Access Compliance Report

Public Rights-of-Way

(Curb Ramps)

Intersection ID: 19036	Main Street: RANDOLPH_RD	Cross Street: RANDSTONE_CT	Location:	N
ADA ID: D7166F81522D	Ramp Type: PerpDiag	Initial Pass/Fail: Fail	Overall Compliance: No	Severity Score: 22.5
Codes/Mitigation Info/Possible Solution		Field Measurements/Component Compliance

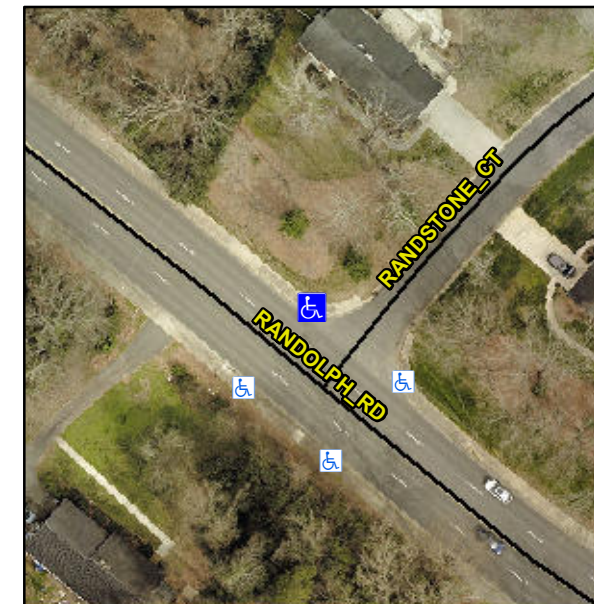
Not Found, R304.5.1, R304.2.2, R304.5.3

Compliance	Description	Data	Compliance	Description	Data
N/A	Ramp Length (in)	61.5	No	Ramp Slope (%)	9.1
No	Ramp Width (in)	47.0	No	Ramp XSlope (%)	3.8
N/A	Flare Type LT	N/A	N/A	Flare Type RT	N/A
N/A	Flare Slope LT (%)	N/A	N/A	Flare Slope RT (%)	N/A
N/A	Flare Traversable LT?	N/A	N/A	Flare Traversable RT?	N/A
N/A	Landing Length (in)	N/A	N/A	DWS Provided?	N/A
N/A	Landing Width (in)	N/A	N/A	DWS Contrast?	N/A
N/A	Landing Slope (%)	N/A	N/A	DWS Length (in)	N/A
N/A	Landing X Slope (%)	N/A	N/A	DWS Full Width?	N/A
N/A	Landing Curb? (Y/N)	N/A	N/A	DWS Offset (in)	N/A
N/A	Shared Landing?	N/A			
N/A	Gutter Ponding?	N/A	N/A	Gutter Slope (%)	N/A
N/A	Gutter Lip Ht (in)	N/A	N/A	Gutter X Slope (%)	N/A
N/A	Painted X Walk1?	No	N/A	Painted X Walk2?	No
	X Walk 1 Direction	To SW		X Walk 2 Direction	To SE
N/A	X Walk 1 Width (in)	N/A	N/A	X Walk 2 Width (in)	N/A
	X Walk 1 Slope (%)	2.4		X Walk 2 Slope (%)	3.7
	X Walk 1 X Slope (%)	3.1		X Walk 2 X Slope (%)	1.6

Remove & Replace Curb Ramp With Two New Directional Ramps or Equivalent.
